**Amendments to the Drawings**

**REMARKS/ARGUMENTS**

FIG. 21A

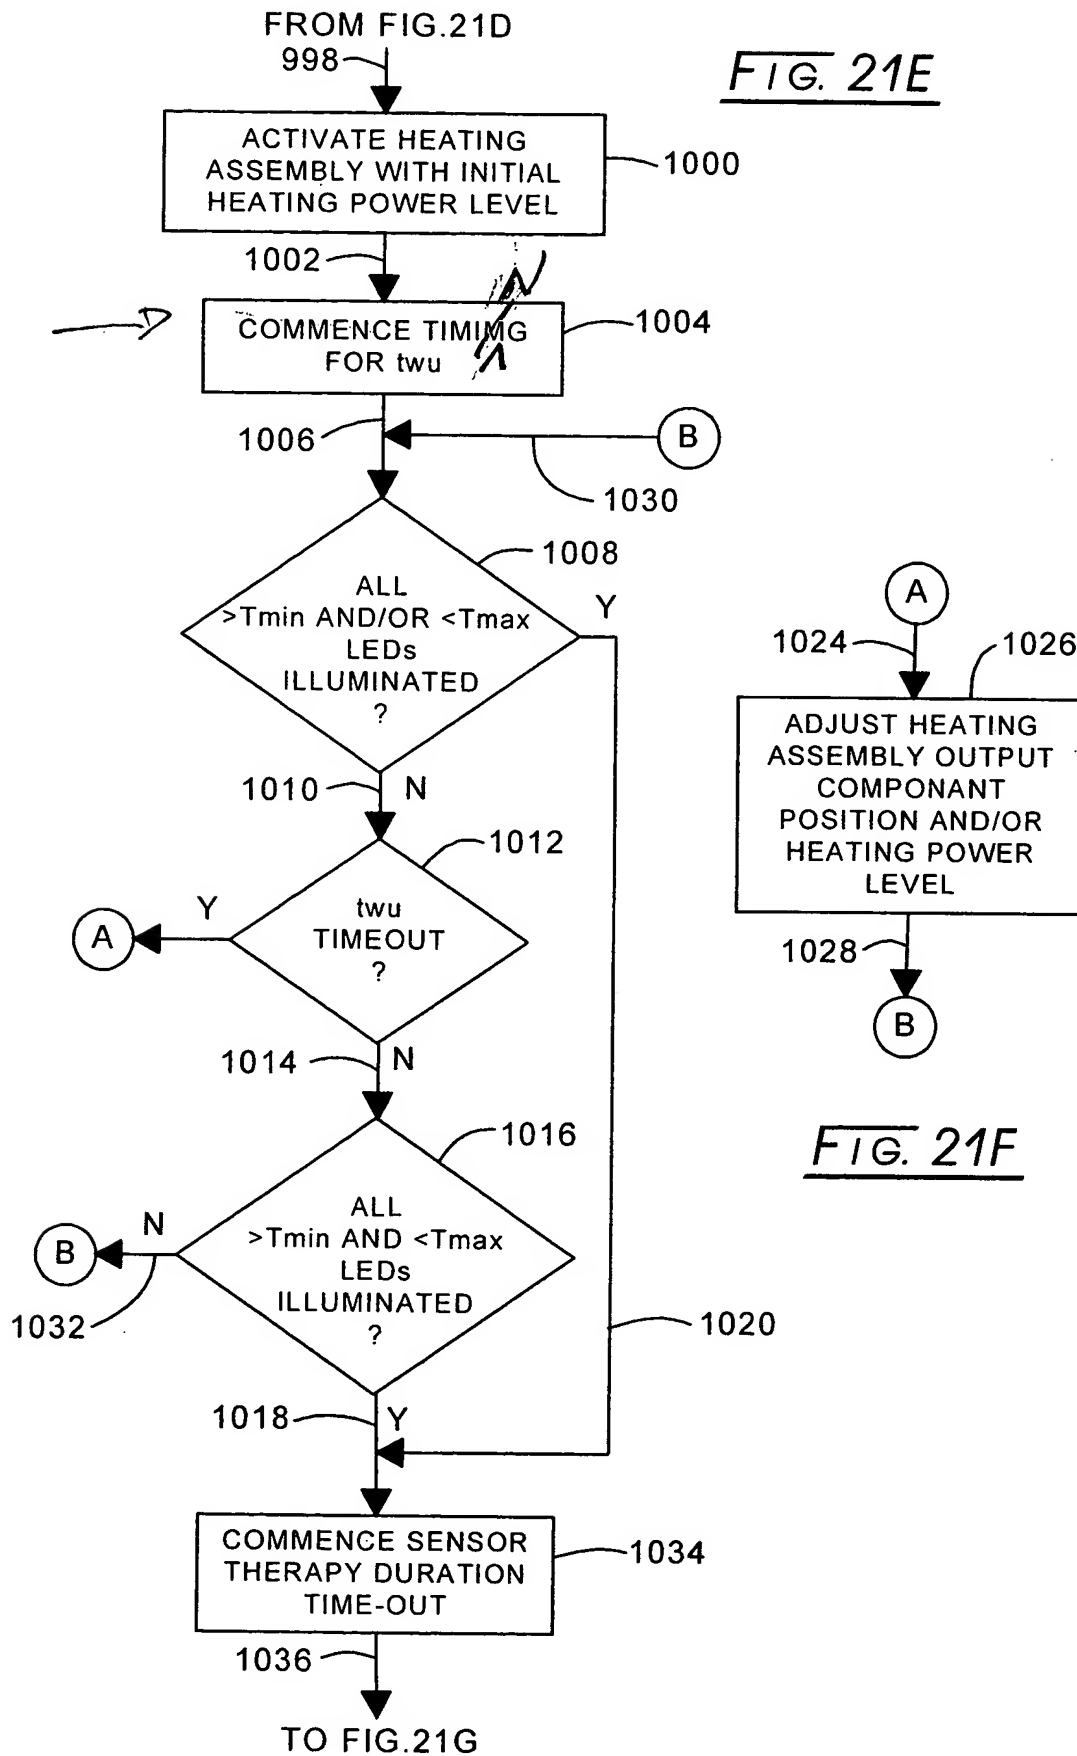
The attached substitute drawing sheets are for the correction of obvious typographical errors in the figure legends. The word "susceptibility" was misspelled in panel 894 of Figure 21A. The word "timing" was misspelled in panel 1004 of Figure 21E. The word "susceptibility" was misspelled in panel 1124 of Figure 23A. There was a missing space in panel 1228 of Figure 23E and the word "component" was misspelled in panel 1262 of Figure 23F. The word "susceptibility" was misspelled in panel 1334 of Figure 24A. The word "timing" was misspelled in panel 1444 of Figure 24E and the word "component" was misspelled in panel 1478 of Figure 24F. The word "susceptibility" was misspelled in panel 1616 of Figure 26A. The word "duty" was misspelled in panel 1692 of Figure 26D. The word "therapy" was misspelled in panel 1760 of Figure 26E. The word "bracketing" was misspelled in panels 2044 and 2048 and an extraneous underscore was deleted from panel 2056 of Figure 38A. The word "integral" was misspelled in panel 2080 of Figure 38B. The word "circulatory" was misspelled in panel 2098 of Figure 39A. The word "turn" was misspelled in panel 2240 and an extra word "console" was deleted from panel 2226 of Figure 39D. Substitute drawing sheets showing these corrections are submitted herewith.

FIG. 38B

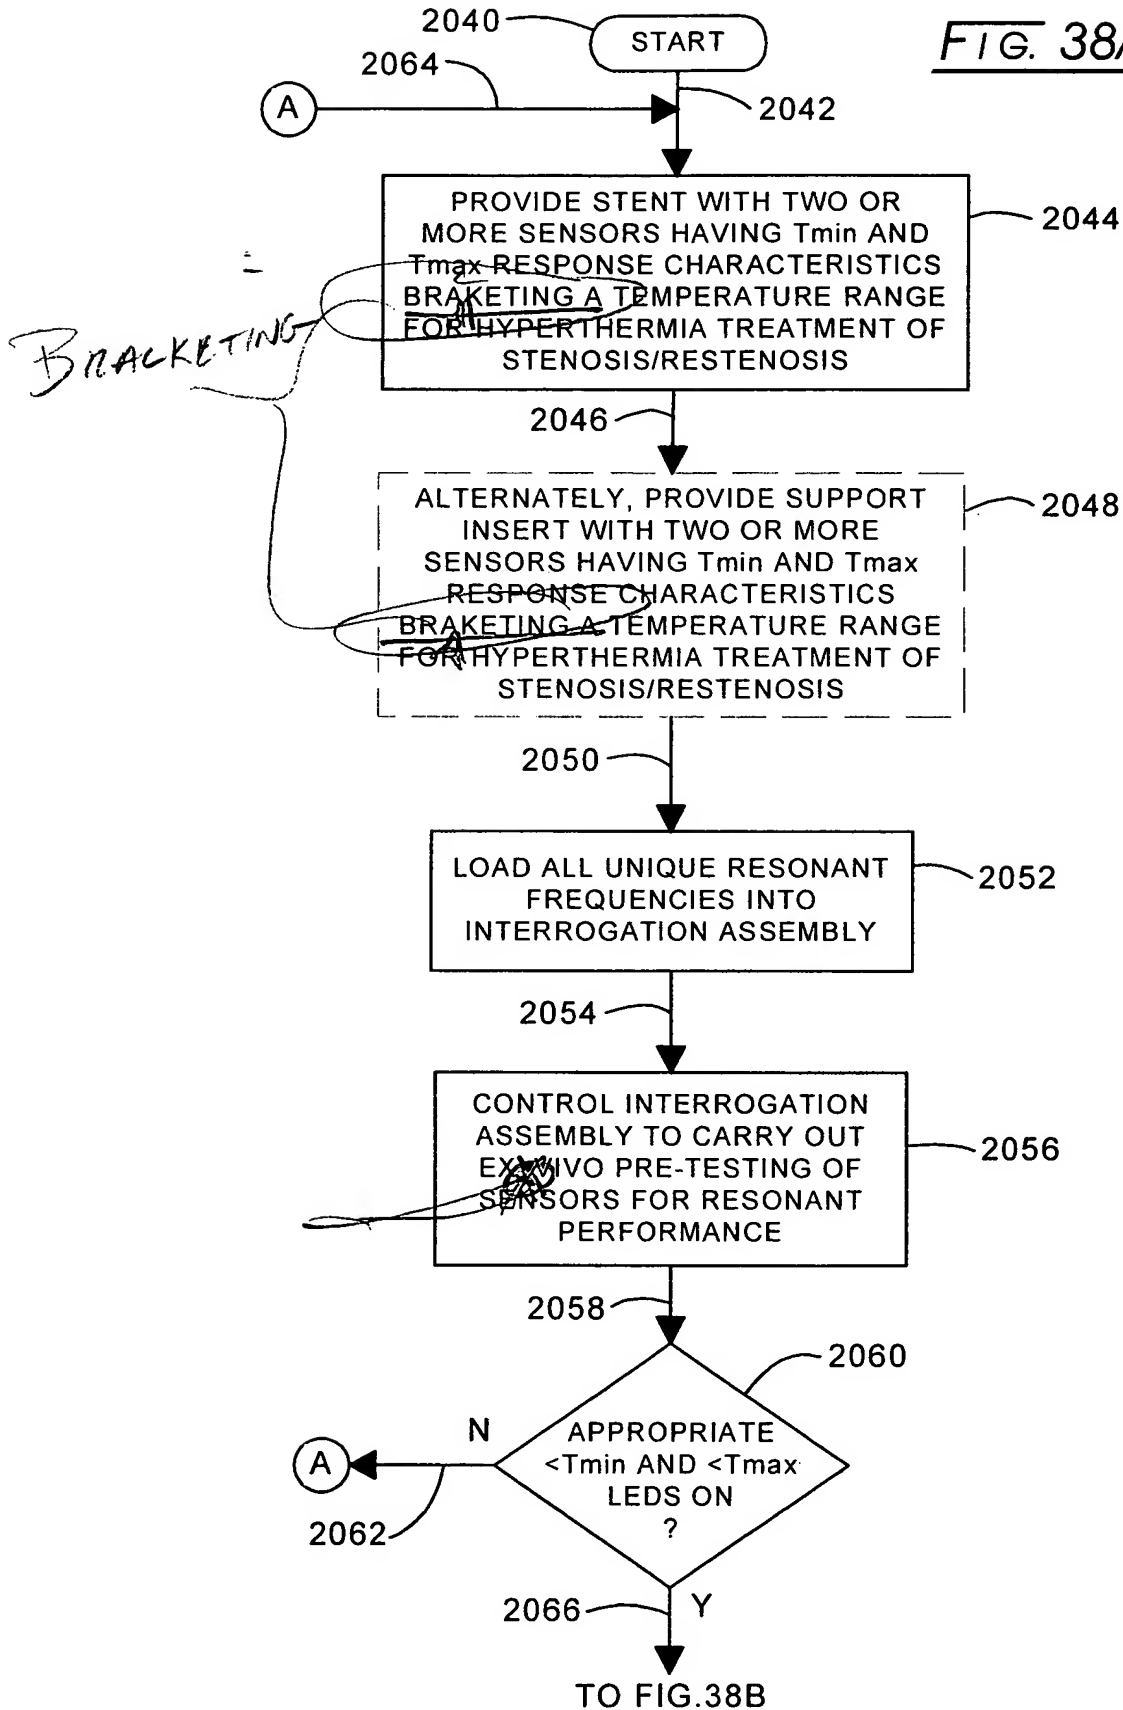
PLACE MARKER ON SURFACE  
(SKIN) OF PATIENT CLOSEST TO  
LOCATION OF STENT WITH  
~~INTEGRAL~~ SENSORS

*INTEGRAL*
